SUBJECT: PDR-623, Adams House

**APPLICANT/
OWNER:** Scott and Shelly Adams

PURPOSE: Application for design review approval to:

Figure 2: Dimensions of a Regulation Tennis Court for Single and Doubles

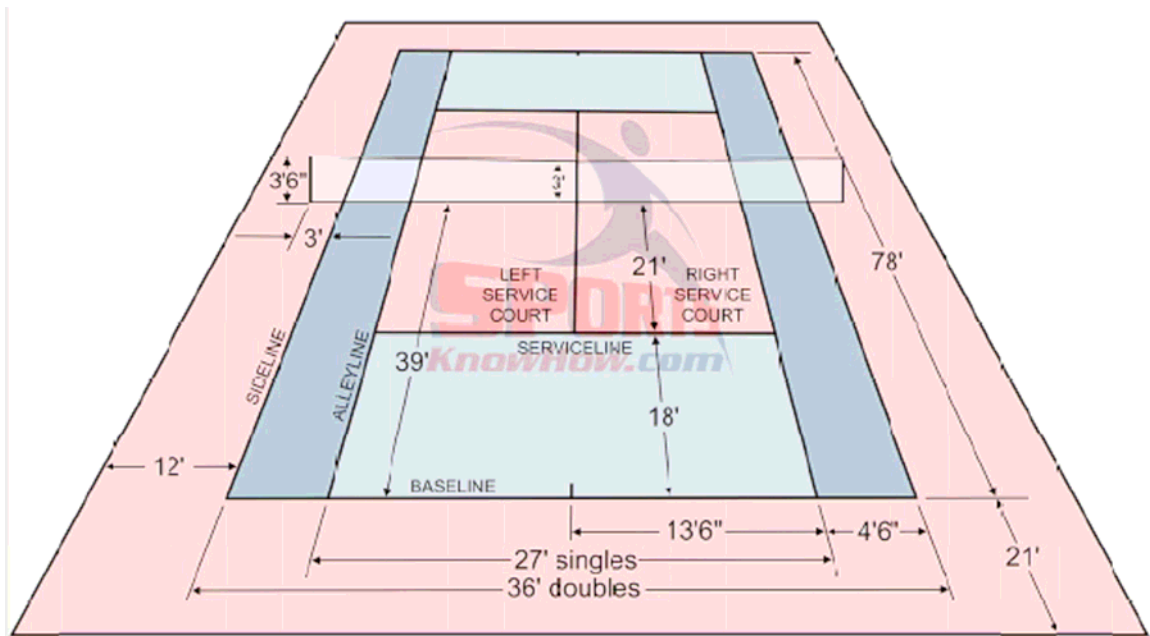
The building enclosing the tennis court is designed for a 36-foot wide by 78-foot long regulation tennis court configured for singles and doubles play. Its interior height would vary from 21 to 23 feet at the "net line" in order to accommodate the building's structural system. Its exterior height would maintain 30 feet. Figure 2, below, is an illustration from "Sports KnowHow.Com" illustrating the dimensions of a regulation-size tennis court. A discussion of the design of an enclosed tennis court is in the attached Work Session Staff Report.
